# Problems wire bonding ColdADC & COLDATA

**David Christian**

Fermilab

December 11, 2024

# Timeline – March-April 2024

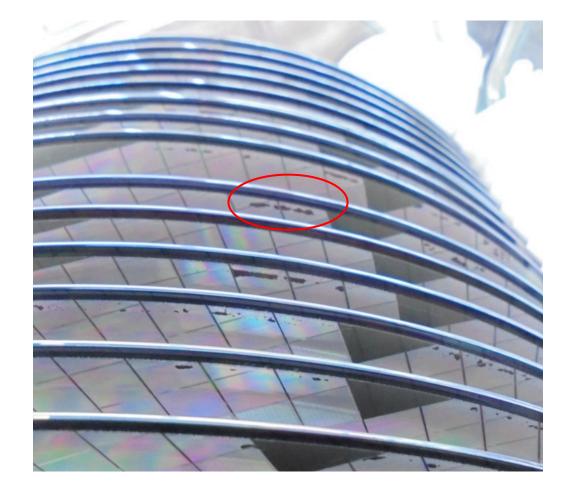
- March 22, 2024 Confirmation that lots NBMY62.00 & NBNA38.00 were received by ASE in Taiwan.
- April 22, 2024 Defects observed on incoming wafers.
  - "operators observed glassivation issue"

There are risks with using these wafers and we require waiver that we are ISE/ASE is not liable for any yield issues or quality issues with the assembly of these wafers.

It has risk to taping BG tape non-sticking on wafer edge due to uneven surface.

It has risk to encountering wafer crack and bond pad contamination during grinding process.

- Contacted Kostas Kloukinas (CERN)
  - He had not seen similar damage before, and he forwarded my email to IMEC with the request to contact TSMC for advice.
  - We gave the OK for ASE to thin one set of 25 wafers.
